To Whom It May Concern
 STATEMENT OF APPLICATION

We, FUJITSU GENERAL (EURO) GmbH, hereby state that from a technical point of view the separation tubes UTP-AX054A can be replaced with UTP-AX090A.

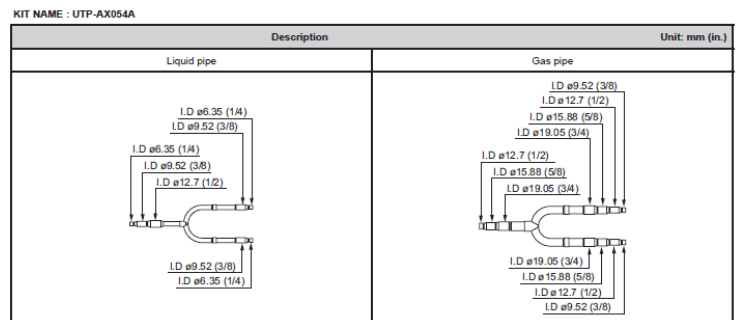
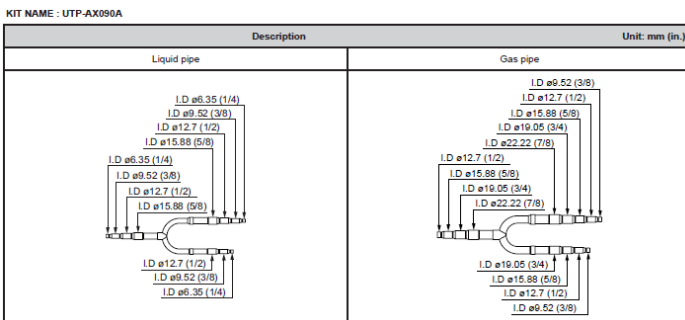
The sizes for the pipe connections on the UTP-AX054A also exist on UTP-AX090A.

It is to consider, that the length of the separation tube set will increase a bit.

Further considerations, e.g. with the calculation of the total refrigerant amount, are not necessary.

The Installation manual is valid for both sizes and must follow up by the installer.
